AGENDA
City of Milton
Plan Commission
Tuesday, June 7, 2016
5:00 pm
MILTON CITY HALL
Council Chambers, 710 S. Janesville Street

To: City of Milton Plan Commission, Mayor Anissa Welch, and Common Council Members
From: Howard Robinson, Director of Public Works
Date: 06/07/2016
Subject: Discussion and Possible Action Regarding a Site Plan for Outdoor Seating at Fredricks Supper Club located at 118 Merchant Row.

To: City of Milton Plan Commission, Mayor Anissa Welch, and Common Council Members
From: Howard Robinson, Director of Public Works
Date: 06/07/2016
Subject: Discussion and Possible Action Regarding a Site Plan for Mini-Storage Warehouses at Pastorius Rentals, LLC located at 1135 S. Janesville Street.

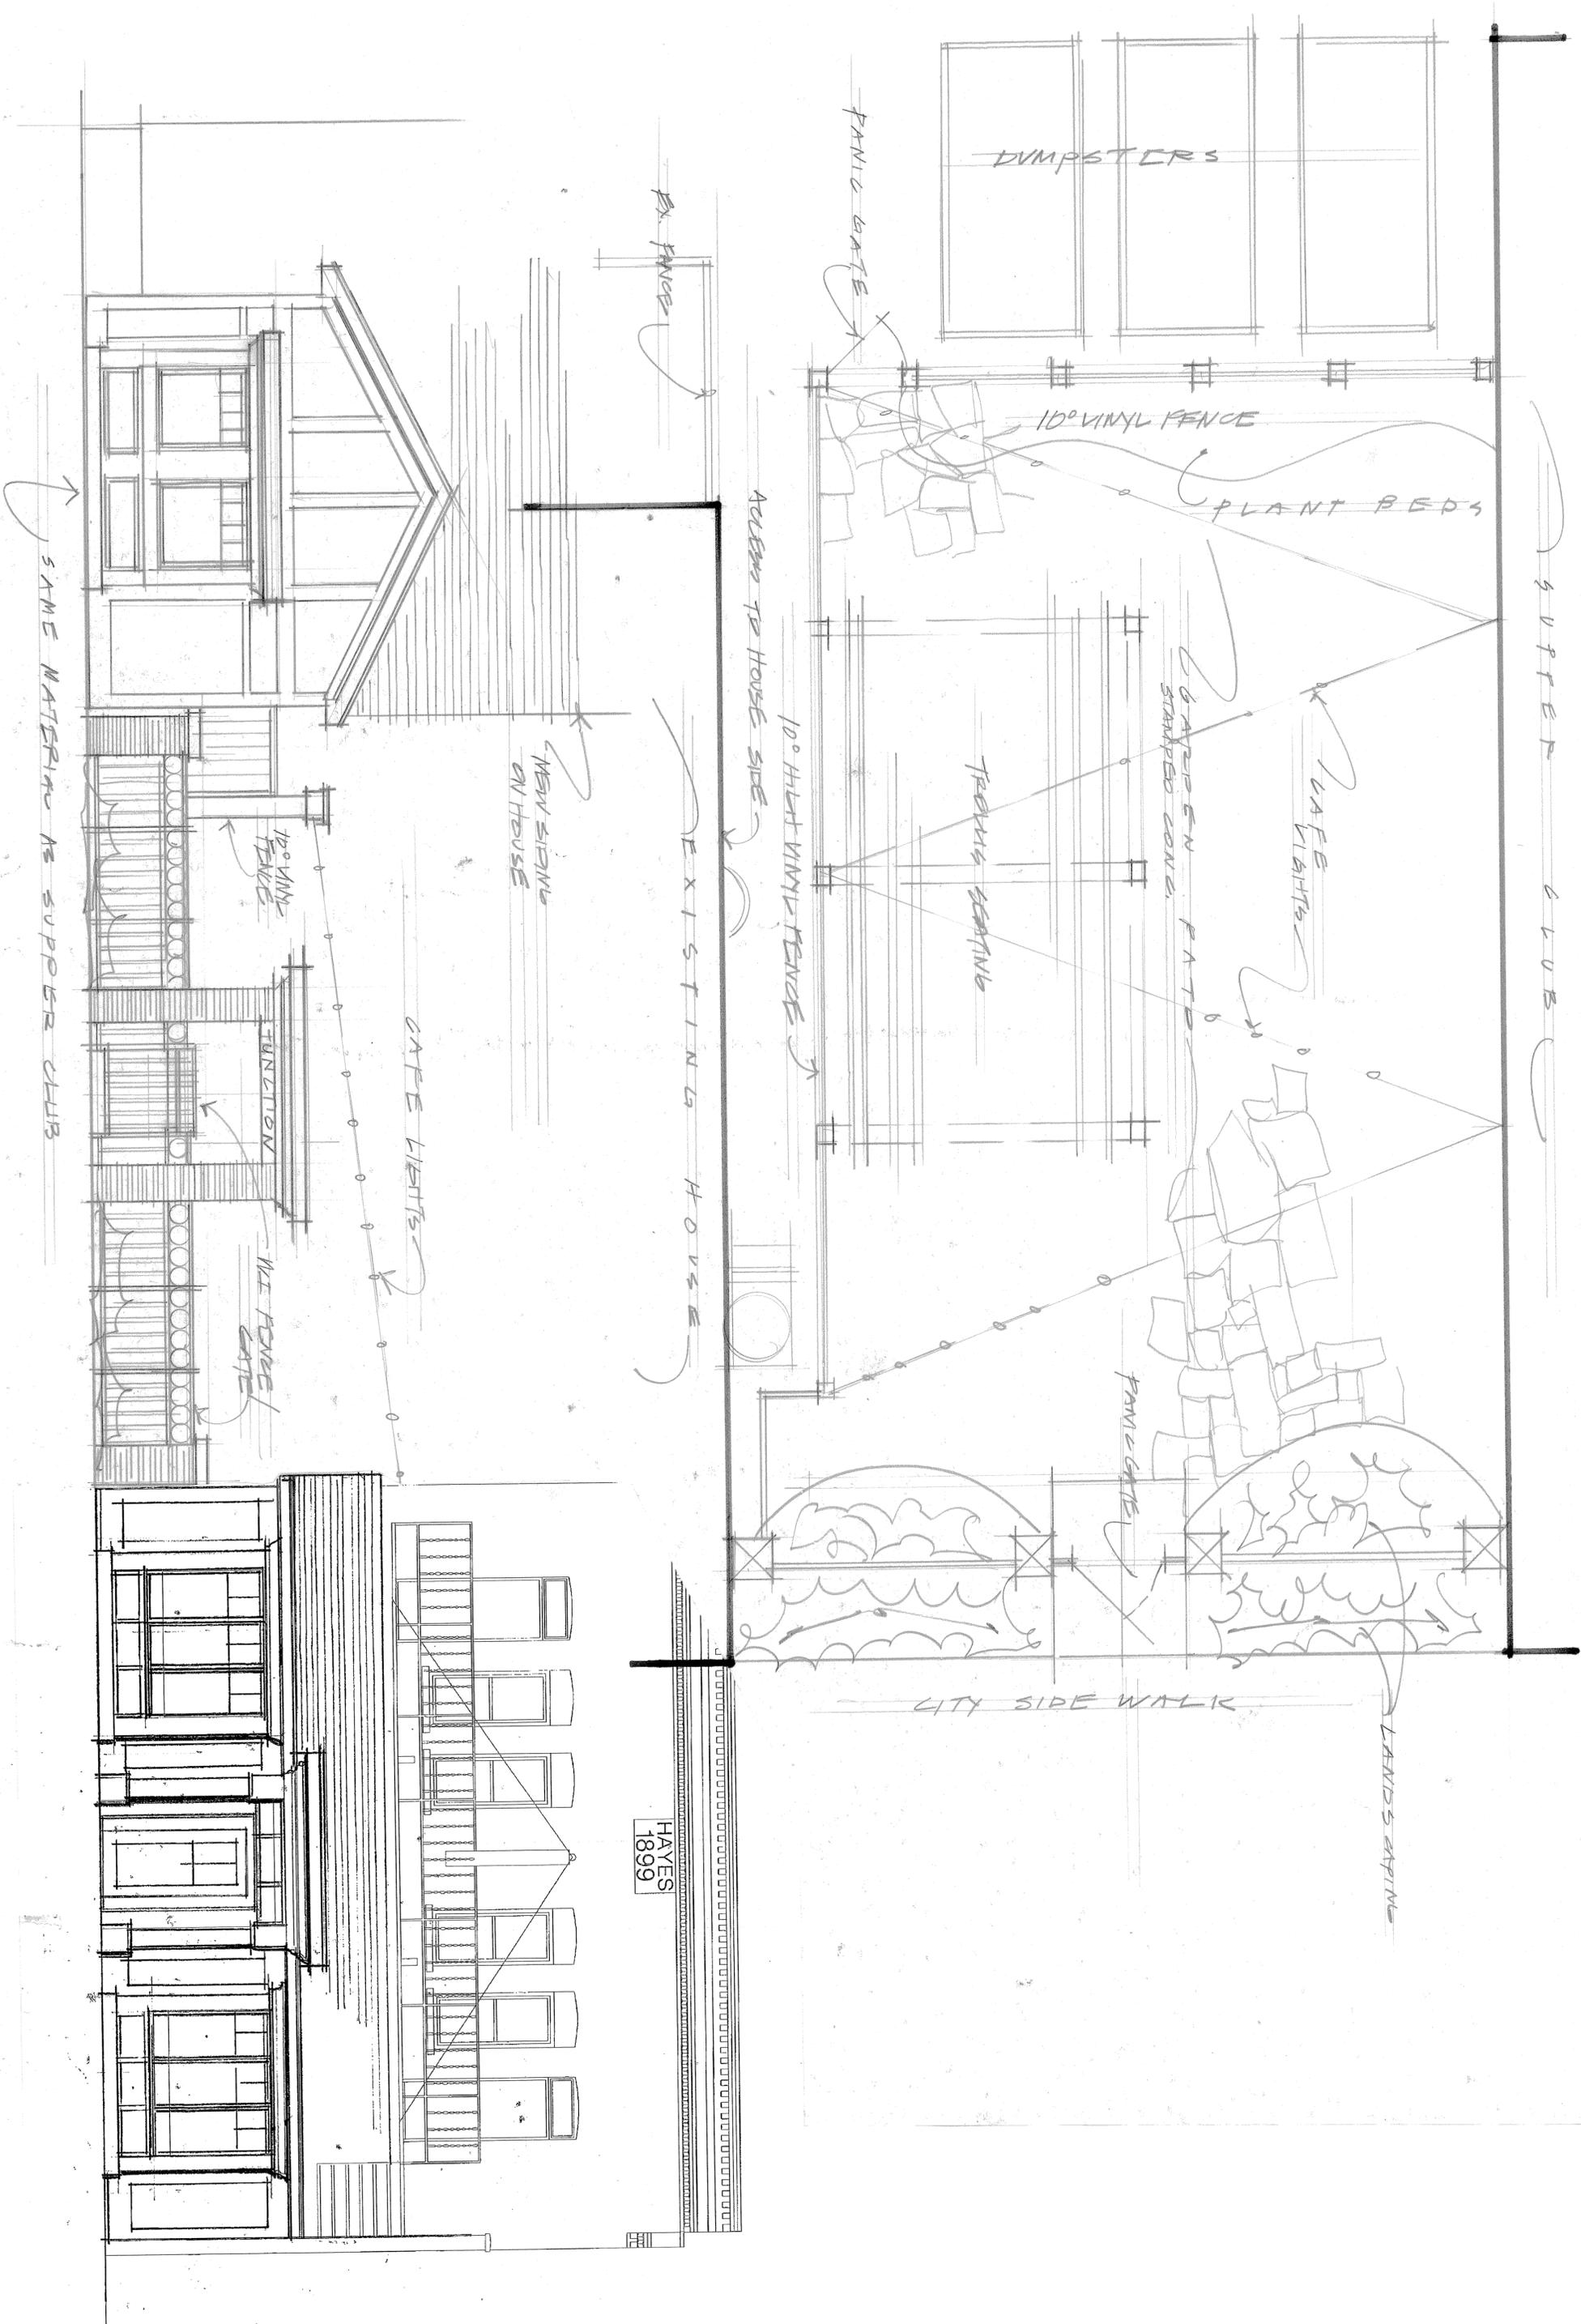
A site plan review is being requested to allow a patio seating area be installed between Fredricks Supper Club located at 118 Merchant Row and the building located to the north of Fredricks located at 106/108 Merchant Row. A design is included in the packet. The patio will be fenced in. The rear (east) fence will be solid to shield the dumpsters and restaurant equipment from the patio area. Landscaping will be provided along the front fence. The building at 106/108 Merchant Row will receive a new front that matches the Fredericks Supper Club materials. The other sides of the building will receive new siding.

The patio site plan meets city requirements. Fences in the B-3 commercial area are part of a site plan approval.

I would recommend to approve the site plan for outdoor seating at Fredricks Supper Club located at 118 Merchant Row.

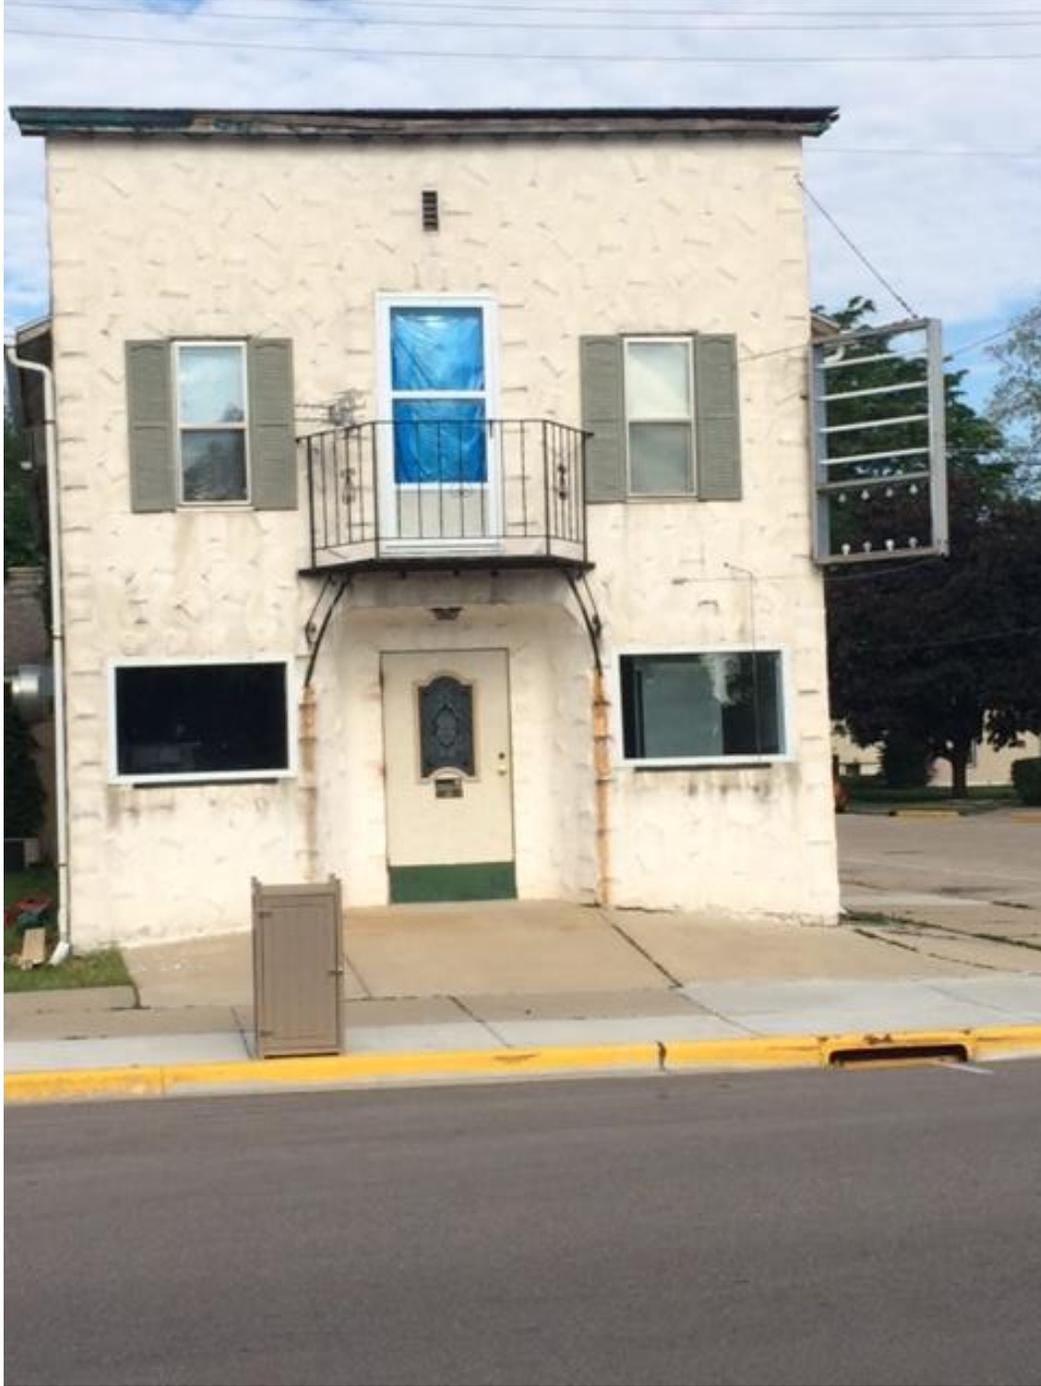
Rochelle Thippayoth has submitted a copy of a sign they are proposing to install at their pizza and sub restaurant located at 301 Parkview Drive. This is the former Georgio's Pizza. They are using the existing sign frame on the building.

Recommend approval of the site plan as presented for the proposed sign for Rockie's Hometown Pizza and Subs.

FILE NO.
06577024
 SHEET
ST 2

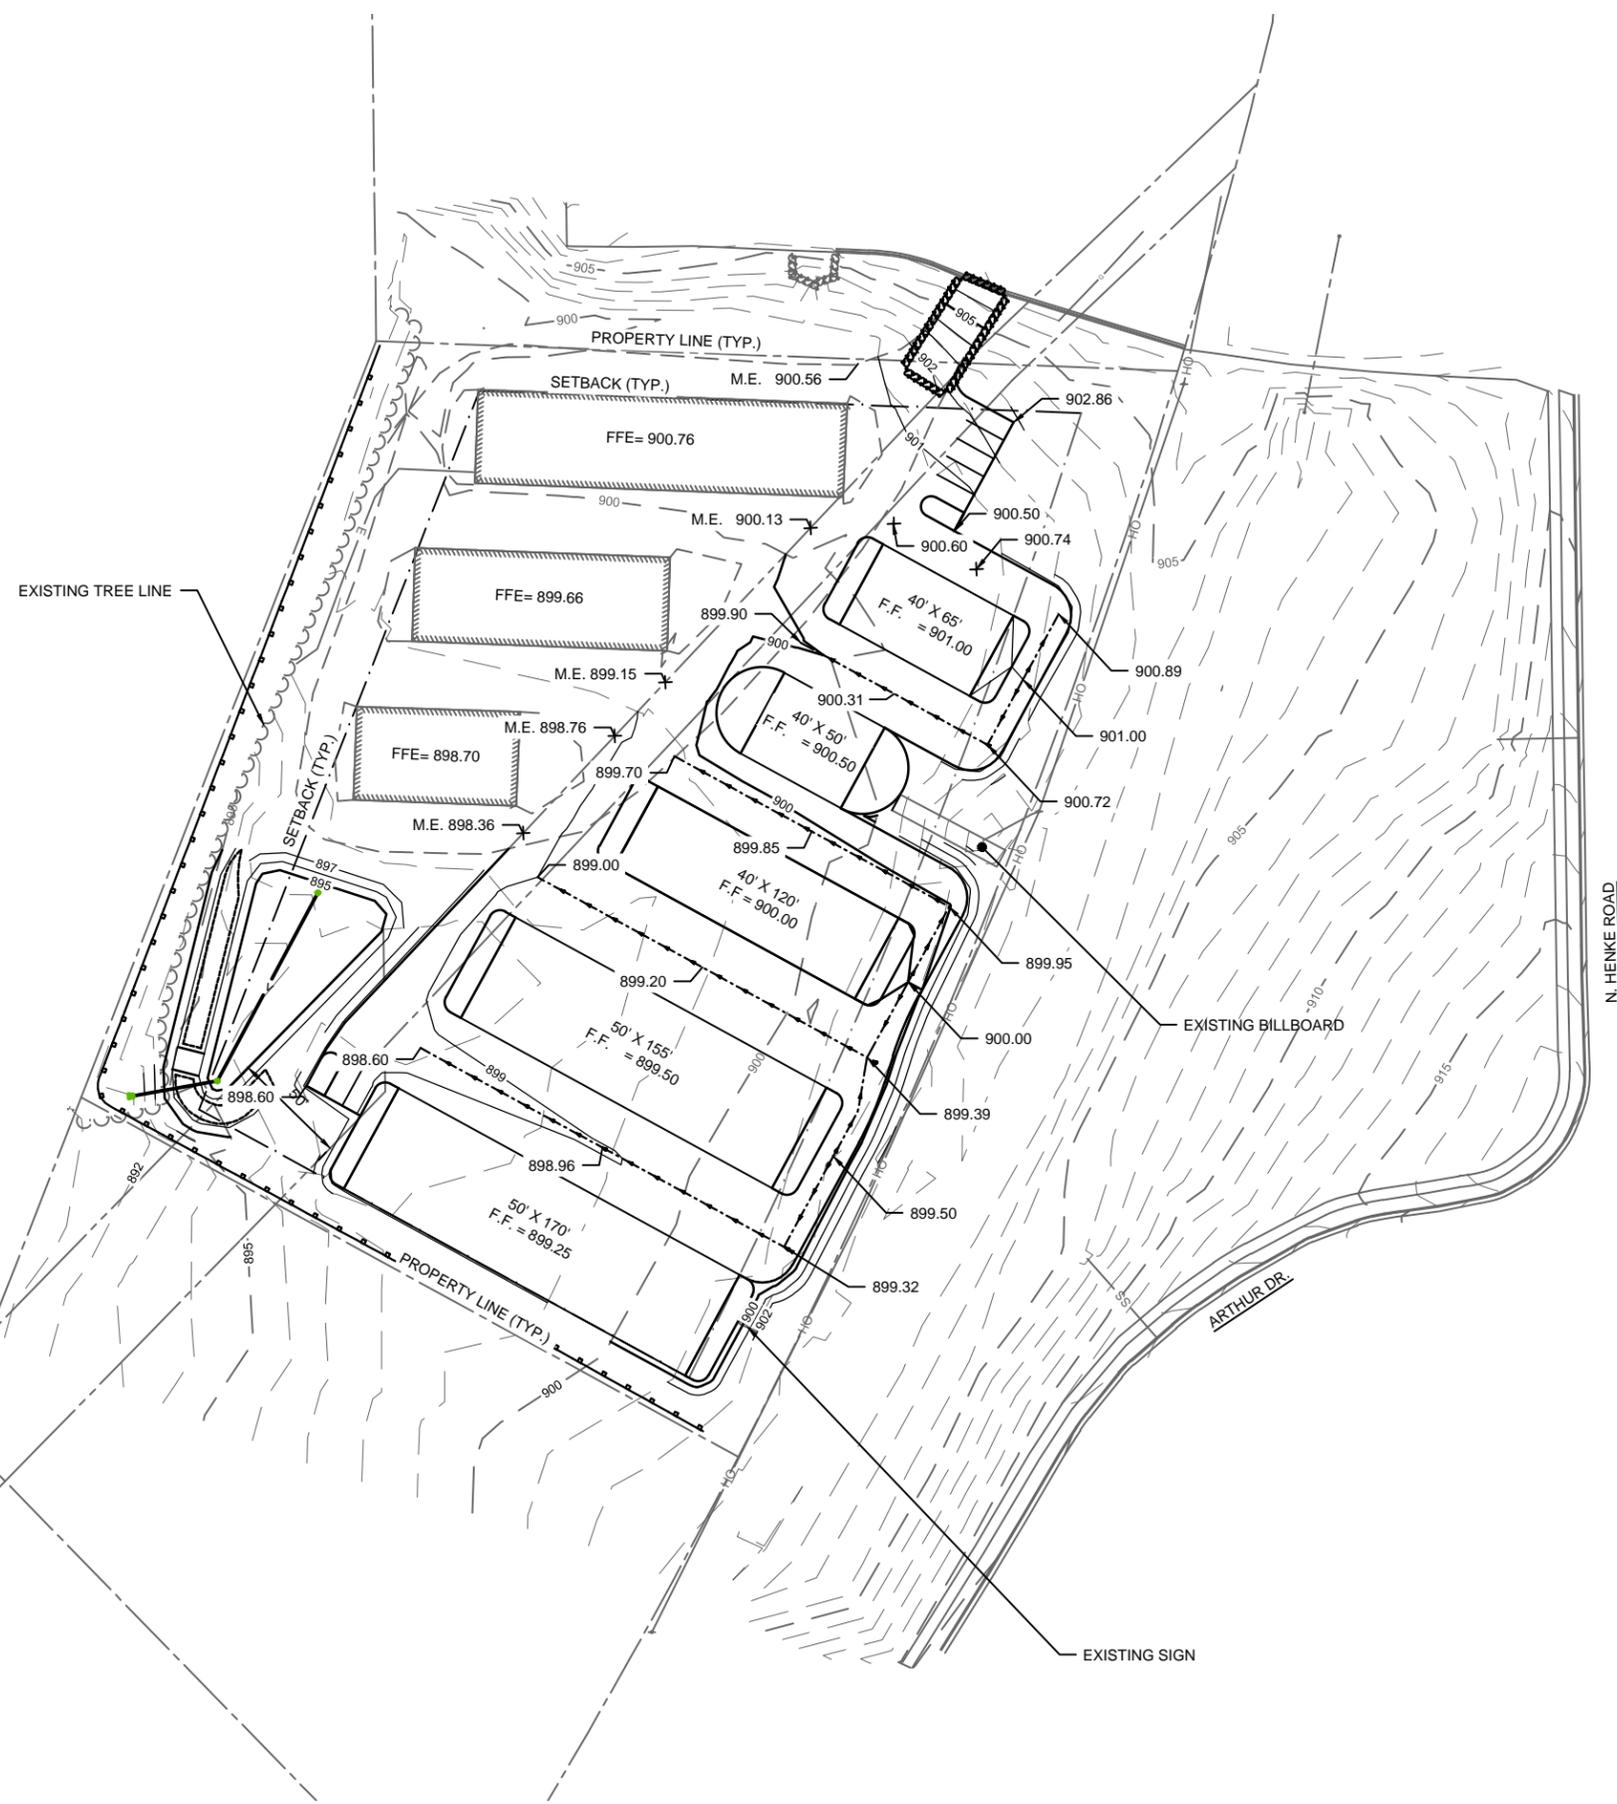
A site plan of the existing and proposed building layouts are included. The building setbacks meet city ordinance requirements. A landscape plan is provided; 30% greenspace is the minimum requirement and they have 35.1% so they have provided enough landscape. No outside storage is planned. An existing tree buffer line is on the side which meets the buffer requirement between them and the residential property to the west. No new points of ingress are needed. They share an existing driveway with Freedom Graphics. No outside trash containers are planned. Signs on the current building meet the sign ordinance. These are allowed to be on the front of the planned buildings if the owner desires to move them. A lighting plan has been submitted. The lights meet ordinance requirements. A grading and drainage plan is included. Our engineers from Baxter and Woodman have reviewed this. A maintenance plan is included for the storm water area. The maintenance plan needs to be recorded. Architectural drawings are included. The colors will match the current buildings as close as possible. The size of the buildings meet ordinance requirements. The state of Wisconsin also reviews the building plans for approval.

I would recommend to approve the site plan for mini-storage warehouses located at 1135 S. Janesville St. as they have met all ordinance requirements.
